DEVELOPMENT REVIEW BOARD
UTILITY DEVELOPMENT
Standard Comment Sheet

DRB- 1004480

**Development Review Board 12/7/05 Agenda Item #17
Sketch Plat: Lots 1, 2, 3, 4, 5, and 6A, Block 13, Timoteo
Chavez Addition**

RE: Tract 126-A, MRGCD Map 39/sketch

Proposed Subdivision
of tract 126-A
MRGCD Map No 39

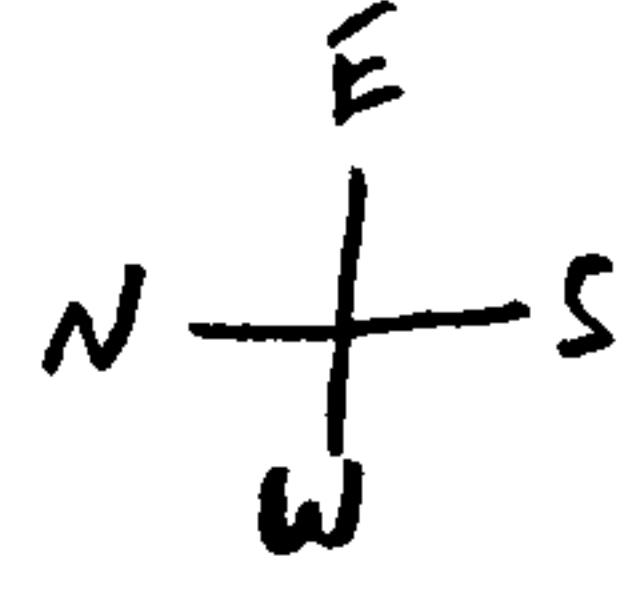
1. Must request and have issued a water/sewer availability statement prior to Preliminary Plat application.
2. Access and utilities must be provided to Lot 125A at north east corner of proposed plat.
3. A new fire hydrant will be required, constructed at developer expense.

- 1) Will access be provided to tract 125A?
- 2) Access for 3 lots can be accommodated with a 22' access easement. (Gravel with the initial 25' paved.)
- 3) Are the sidewalks and curb and gutter in place on 47th street?
(infrastructure may be required)
- 4) The cul-de-sac will need a radius per the DPM.

Is there adequate access easement width to the rear lot?

This request meets the R-1 zone requirements for lot size.

Request to subdivide 1.15 acres in fill
zoned R-1 - keep R-1 divide into 7
Residential lots; for use of this land

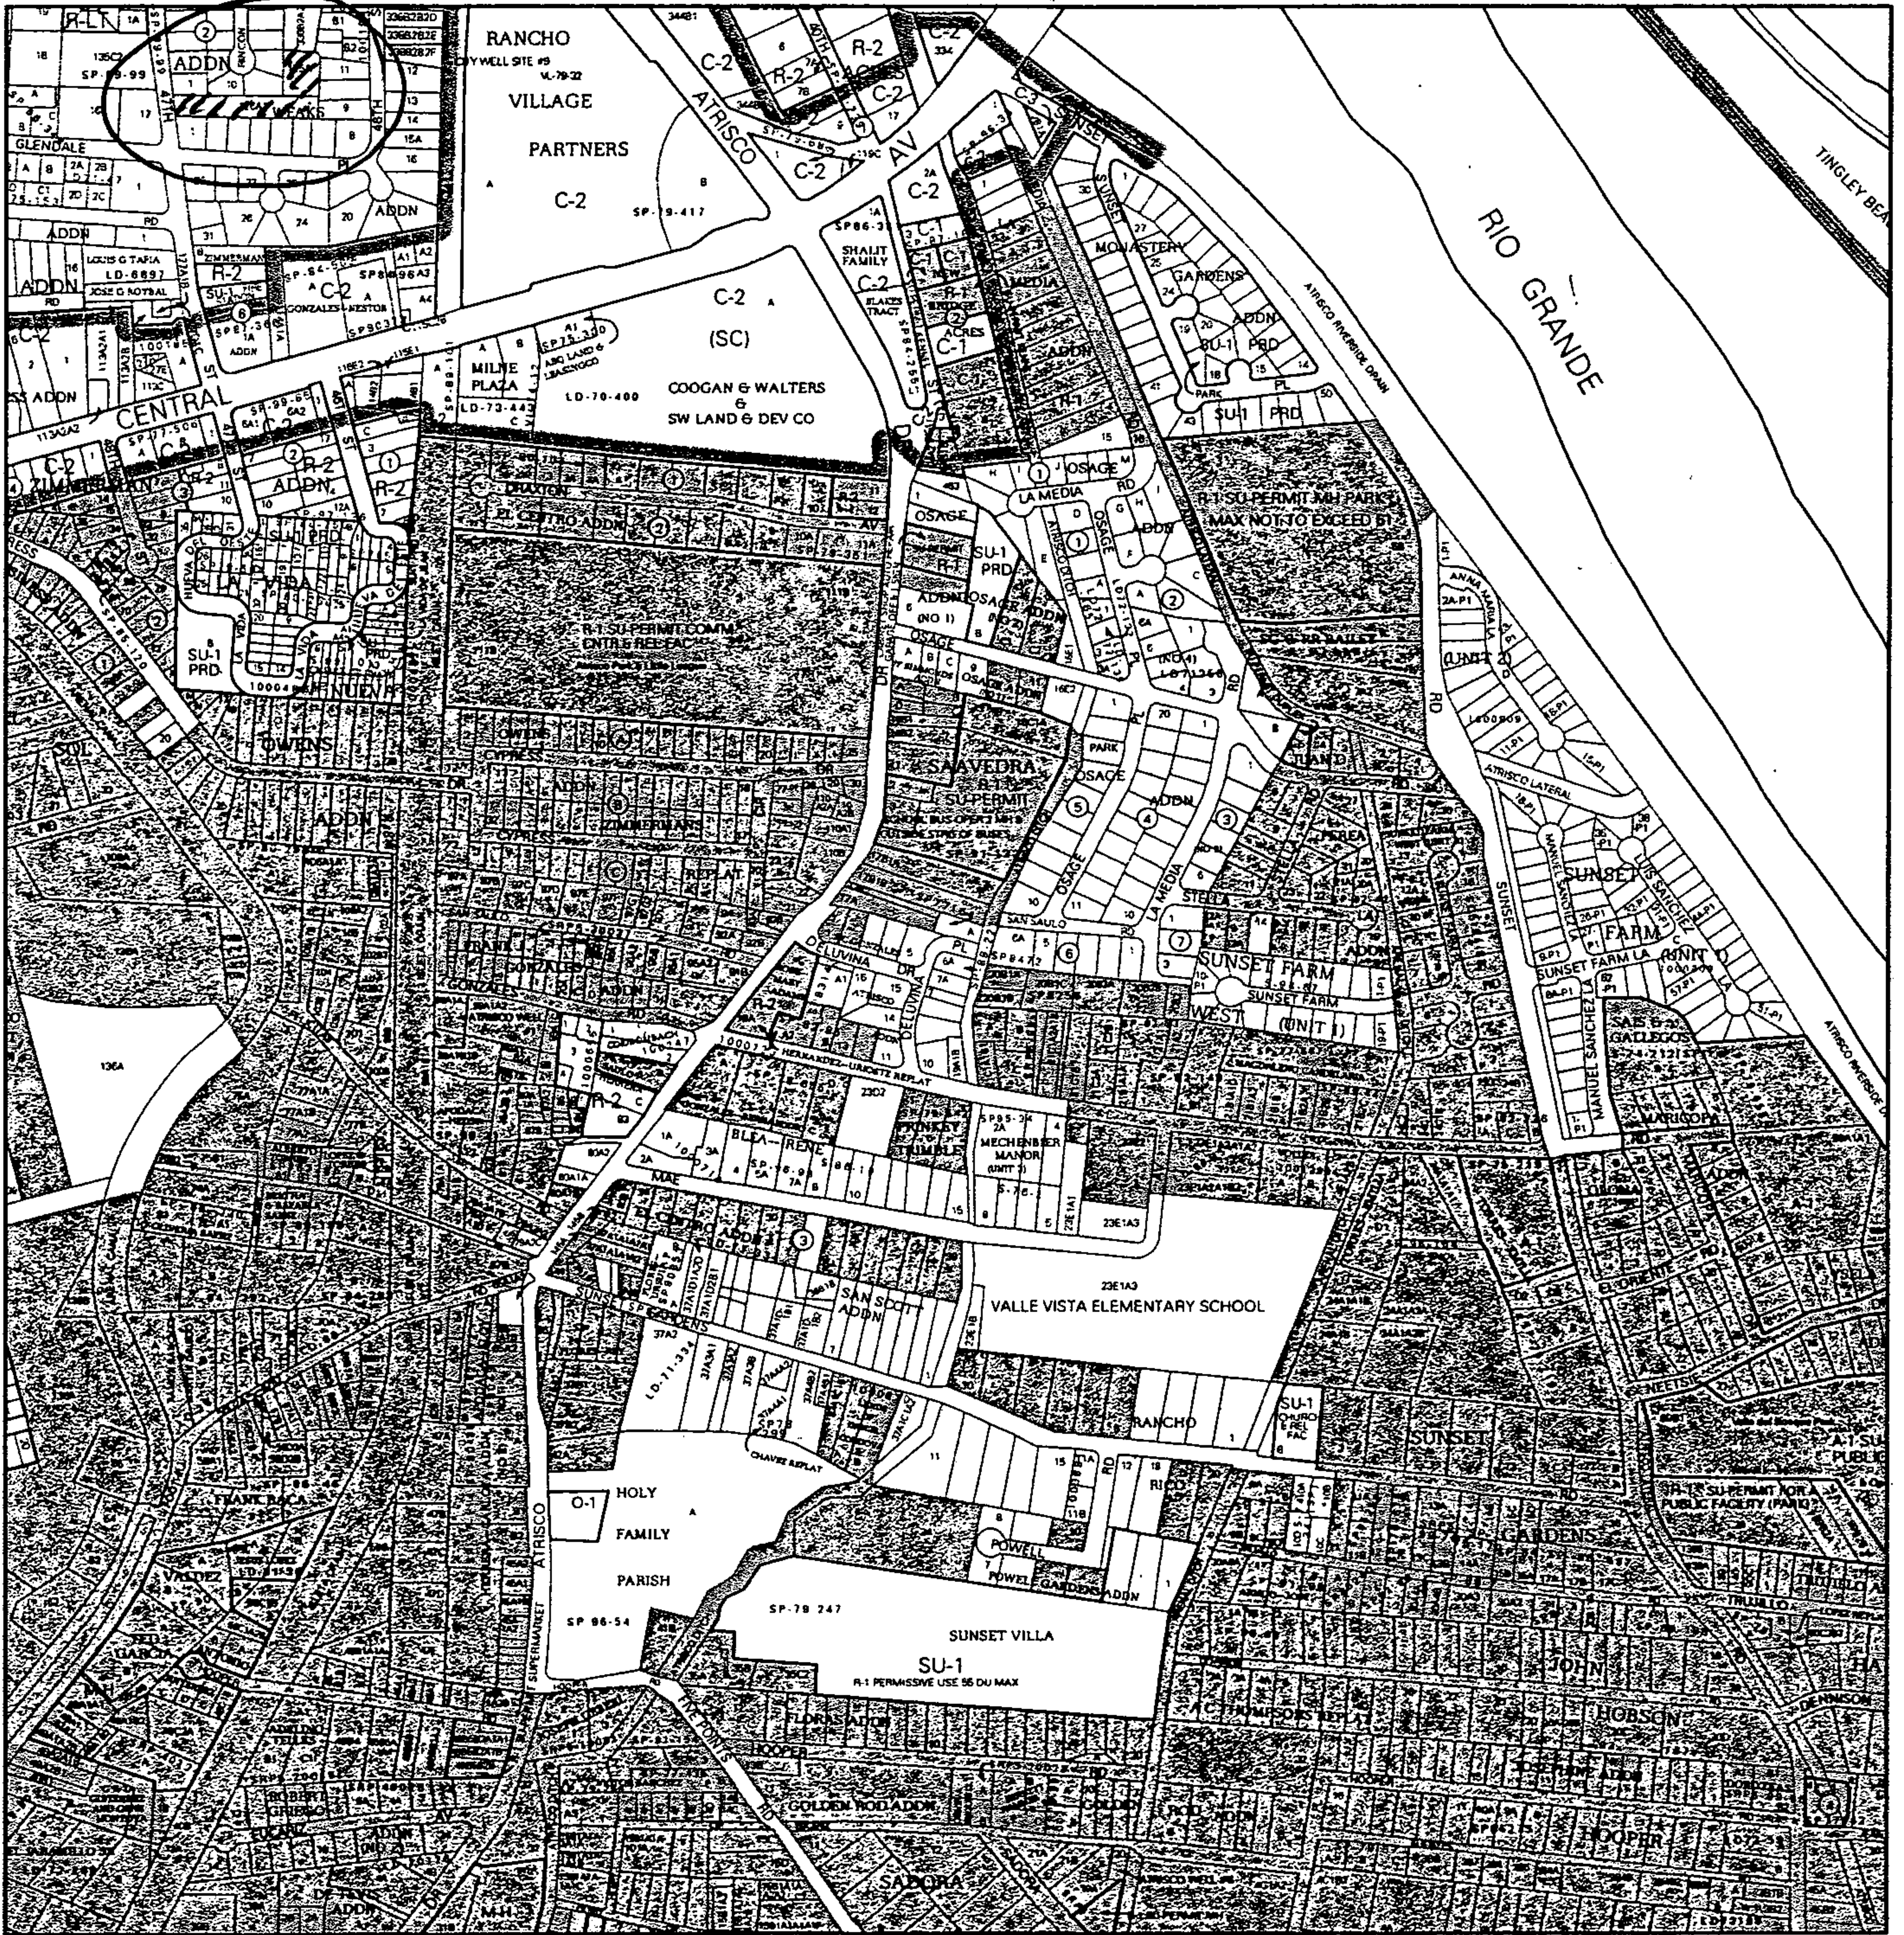
- 1) The access road does not meet DPM requirements.
- 2) Is there an access easement for the radius on lot 1?
- 3) Are any improvements required for 47th street? What is the right-of-way width and cross-section?
- 4) The length of private access will require a cul-de-sac.
- 5) Can sight distance be met at entrance to 47th street?

A few lots do not meet the minimum lot size requirement in the R-1 zone of the Zoning Code.

Does not meet the minimum lot width.
